UNITED STATES PATENT AND TRADEMARK OFFICE

APPLICATION NO.	FILING DATE	FIRST NAMED INVENTOR	ATTORNEY DOCKET NO.	CONFIRMATION NO.
10/790,477	03/01/2004	Kenneth N. Harel	CONTC.64501	9529
27629	7590	06/15/2005	EXAMINER	
FULWIDER PATTON LEE & UTECHT, LLP 200 OCEANGATE, SUITE 1550 LONG BEACH, CA 90802			HORTON, YVONNE MICHELE	
			ART UNIT	PAPER NUMBER
			3635

Office Action Summary

DETAILED ACTION

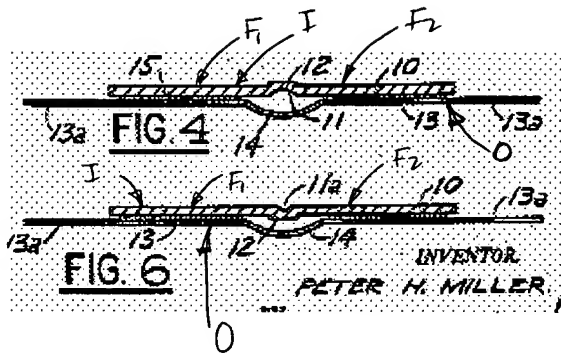
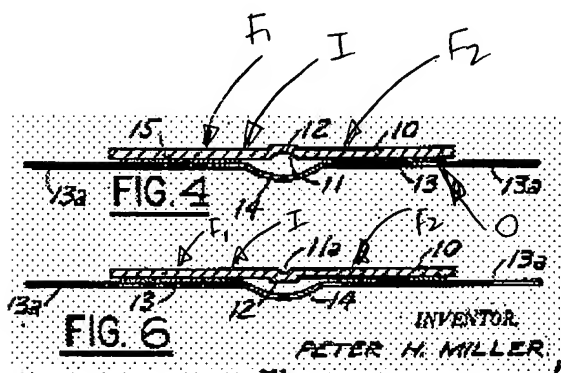
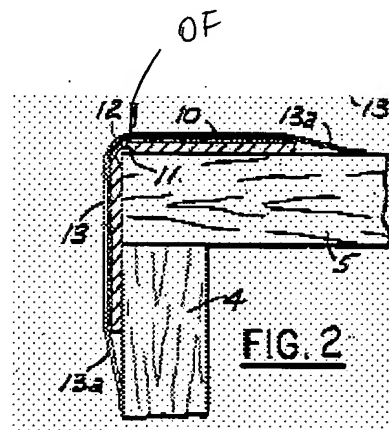
Claims 31-34 are rejected under 35 U.S.C. 103(a) as being unpatentable over US Patent #3,090,087 to MILLER in view of US Patent #4,863,774 to TUCKER. MILLER discloses a drywall accessory including an elongate core (10) having inward (I) and outward (O) faces, a corner portion (as at 11 & 12), and at least one flange (F1,F2) projection transversely from the length of the corner portion (as at 11 & 12), see the attachment below. MILLER further includes an elongate paper strip (13) affixed to an

outward face (OF) of the core strip and extending from end-to-end thereof, with a (13a) forming a flap. MILLER discloses the basic claimed accessory except for including uniform depressions on the flap. TUCKER teaches that it is known in the art to provide the flaps (as at 82) of a drywall accessory with uniform depressions (20,22). Hence, it would have been obvious to one having ordinary skill in the art at the time the invention was made to provide the flaps of the drywall accessory of MILLER with the uniform depressions of TUCKER in order to improve adhesion of the device to the drywall. In reference to claim 32, the depressions (20,22) of TUCKER are uniformly spaced apart across a portion (the entirety) of the flap (as at 82). Regarding claim 33, the drywall accessory is a corner bead wherein the flanges (F1,F2) project transversely from the length of the central/corner portion (as at 11 & 12), and the paper strip (as at 13a) projects transversely from the length of the flanges (F1, F2). In reference to claim 34, the core/corner/central portion is metal, column 2, line 56.

Claims 35 and 36 are rejected under 35 U.S.C. 103(a) as being unpatentable over US Patent #3090,087 to MILLER in view of US Patent #4,863,774 to TUCKER. The accessory of MILLER inherently discloses the steps of selecting an elongate core (10) with inward (I) and outward (O) faces, a corner portion (as at 11 & 12), and at least one flange (F1,F2) projection transversely from the length of the corner portion (as at 11 & 12), see the attachment below. MILLER further includes the step of selecting an elongate paper strip (13) and affixing the paper strip (13) to an outward face (OF) of the core strip and extending from end-to-end thereof, and thereby forming a flap (13a).

MILLER discloses the basic claimed method except for including uniform depressions on the flap. TUCKER teaches that it is known in the art to form uniform depressions (20,22) in the flaps (as at 82) of a drywall accessory. Hence, it would have been obvious to one having ordinary skill in the art at the time the invention was made to form uniform depressions in the flaps of the drywall accessory of MILLER, as taught by TUCKER, in order to improve adhesion of the device to the drywall. Regarding claim 36, MILLER discloses the step of selecting flanges (F1,F2) project transversely from the length of the central/corner portion (as at 11 & 12), and the paper strip (as at 13a) projects transversely from the length of the flanges (F1, F2).
